DBI Report: 301 Mission Foundation Retrofit

San Francisco Board of Supervisors, GAO Committee
January 6, 2021

Construction Settlement

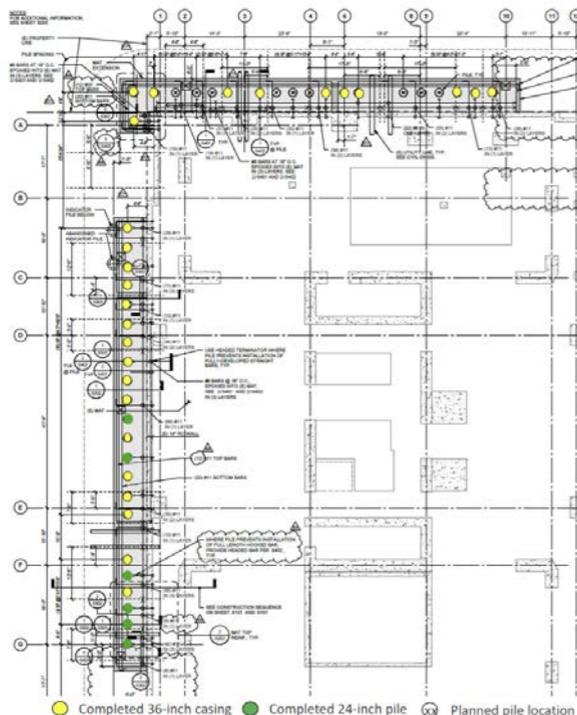
- Accelerated settlement that occurred during initial casing and pile installations (May-Aug 2021) is primarily attributed to disturbance/over-excavation of soil during construction
- Modified construction and monitoring procedures implemented in pilot casing and pile installations have been successful at reducing accelerated settlements
- Current settlement and building tilt rates, while significantly reduced from May-Aug. 2021, remain a concern until such time as they can be arrested by completion of the retrofit.

Effect of Settlement/Tilt on Building Safety

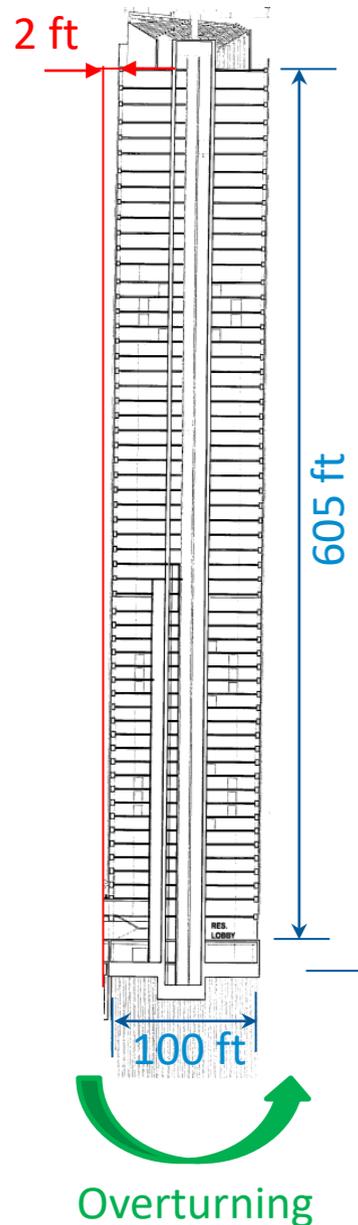
- **Current Tilt: $1/300 = 0.3\%$ (24" to west)**
 - ACI 117 Maximum out-of-plumb 0.1% to 0.3%
 - PEER TBI Service Level Earthquake 0.5%
- **Current Gravity Overturning Moment (P- Δ):**
 - About 6% of Design Earthquake Overturning
- **Maximum Considered Earthquake (MCE):**
 - SGH analyses of building foundation and superstructure consider *combined effect of tilt and MCE earthquake* to establish that building meets minimum requirements per San Francisco Building Code and AB 083 for tall buildings
 - Current tilt (24") has negligible impact on earthquake safety
 - Impact on earthquake safety at larger (3x current) tilt is under review
- **Serviceability**
 - Being monitored, taking corrective actions as needed
